SUBDIVISION COMMITTEE  
METROPOLITAN AREA PLANNING COMMISSION

STAFF REPORT

CASE NUMBER: S/D 93-4 BRADLEY FAIR ADDITION

SUBJECT: Bradley Fair St. Improvements  
PEC Project No. 36-94901-3432

VICINITY MAP:

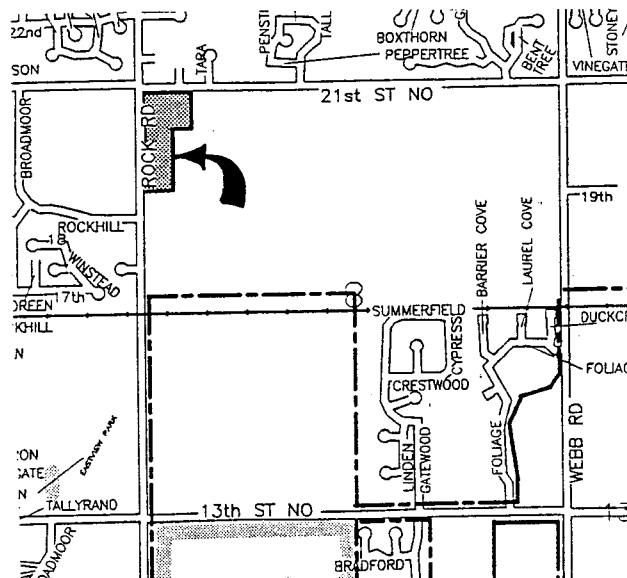
- A. The applicant shall guarantee the extension of sanitary sewer to serve any lots not already served.
- B. The applicant shall guarantee the extension of City water to serve any lots not already served.

- C. The applicant shall guarantee the balance of all road improvements specified on the CUP, including decel lanes, center turn lanes, and the portions of major entrances within public rights-of-way.

- D. City and Traffic Engineering also need to indicate if additional street or traffic improvements, as noted in CUP, DP-191, need to be guaranteed at this time. These improvements involve signalization at major entrance(s) and the Rock/21st Street intersection.

- E. If improvements are guaranteed by petition, a notarized certificate listing the petitions shall be submitted to the Planning Department for recording.

- F. Since the drainage plan for this site indicates drainage will be directed to the property east of the plat, the applicant shall submit for recording with the plat needed drainage agreements and/or easements for such drainage.

- G. Prior to submission of a final plat, the applicant was to file a CUP adjustment request which changes the access controls and parcel (lot) boundaries to match the plat. Maximum gross floor area and maximum building coverage for each parcel shall be changed accordingly, with no overall increase. This adjustment has not yet been submitted, and the applicant is advised that this plat will not be scheduled for City Council review until such a request is approved.

- H. Several joint access easements affecting certain lots in this plat have already been recorded. Additional ones are needed and shall be drafted by separate instrument for submission to the Planning staff for review at the time of, or prior to, submission of the final plat tracing. Also, the plattor's text indicates an access easement on Film 1109, Page 132 but no such easement is shown on the face of the plat. Either the easement's location needs to be shown on the plat or the reference to such an easement deleted from the plattor's text if no such easement exists.

- I. On the final plat tracing, all utility easements shall be labeled and dimensioned; all building setbacks as approved on the CUP (after adjustment for parcel boundary changes) shall be shown and labeled; and all access controls shall match the adjusted CUP.

- J. Prior to this plat being scheduled for City Council review, the applicant shall submit legal descriptions for two areas involved in a zone change to "LC" zoning. Specifically, areas at the southeast corner of Lot 2 and the southeast corner of Lot 3 are still zoned "AA", with zoning to "LC" approved subject to platting (Z-2886)

- K. The applicant shall install or guarantee the installation of all utilities and facilities which are applicable and described in Article 8 of the MAPC Subdivision Regulations.

- L. The applicant's engineer is advised that the Register of Deeds is requiring the name(s) of the notary public, who acknowledges the signatures on this plat, to be printed beneath the notary's signature.

- M. Perimeter closure computations shall be submitted with the final plat tracing. Section 5-101(c).
- N. Recording of the plat within 30 days after approval by the City Council.

- O. The representative from City Engineering should be prepared to comment on the status of the applicant's drainage plan.

VICINITY MAP:

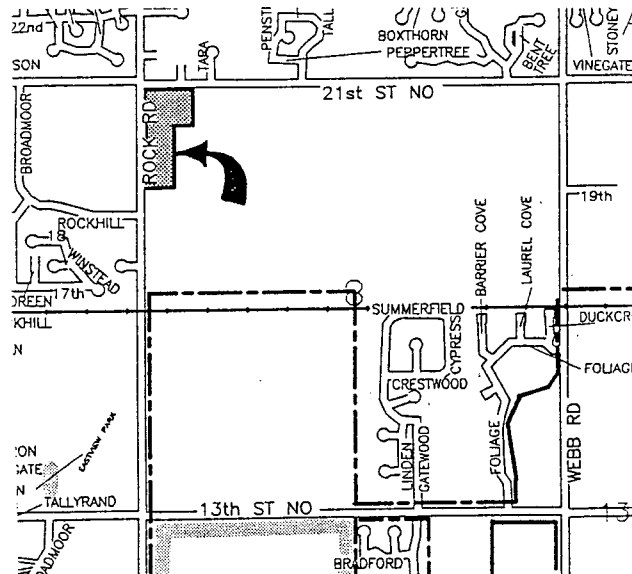
- A. The applicant shall guarantee the extension of sanitary sewer to serve any lots not already served.
- B. The applicant shall guarantee the extension of City water to serve any lots not already served.

- C. The applicant shall guarantee the balance of all road improvements specified on the CUP, including decel lanes, center turn lanes, and the portions of major entrances within public rights-of-way. The Traffic Engineering shall be prepared to comment on the extent (length) to which the decel lanes and turn lanes shall be built.

- D. The Traffic Engineer shall also be prepared to comment on the possible need for signalization of the major entrance into Parcel 4 (Lot 3) as specified in General Provisions 13.E of the CUP as well as the current level of service of the 21st/Rock Road intersection. General Provision 13.F of the CUP states that 25% of the costs of reconstruction shall be borne by properties within this CUP and that reconstruction will be initiated when the service level drops below Level C.

- E. The applicant shall guarantee any drainage improvements required by the platting of this property.
- F. If improvements are guaranteed by petition, a notarized certificate listing the petitions shall be submitted to the Planning Department for recording.

- G. Prior to submission of a final plat, the applicant shall file a CUP adjustment request which changes the access controls and parcel (lot) boundaries to match the plat. Maximum gross floor area and maximum building coverage for each parcel shall be

changed accordingly, with no overall increase.

- H. Several joint access easements affecting certain lots in this plat have already been recorded. Additional ones are needed and shall be drafted by separate instrument for submission to the Planning staff for review at the time of, or prior to, submission of the final plat.

- I. On the final plat, all utility easements shall be labeled and dimensioned; all building setbacks as approved on the CUP (after adjustment for parcel boundary changes) shall be shown and labeled; and all access controls shall match the adjusted CUP.

- J. Prior to or at the time of submitting the final plat, the applicant shall submit a drainage plan to City Engineering for review and approval.
- K. The applicant shall install or guarantee the installation of all utilities and facilities which are applicable and described in Article 8 of the MAPC Subdivision Regulations.

- L. Requirements for a final plat (see pages 24-29, Part 4, Article 5 of the MAPC Subdivision Regulations).
- M. The applicant's engineer is advised that the Register of Deeds is requiring the name(s) of the notary public, who acknowledges the signatures on this plat, to be printed beneath the notary's signature.

- N. The representative from City Engineering should be prepared to comment on the status of the applicant's drainage concept.
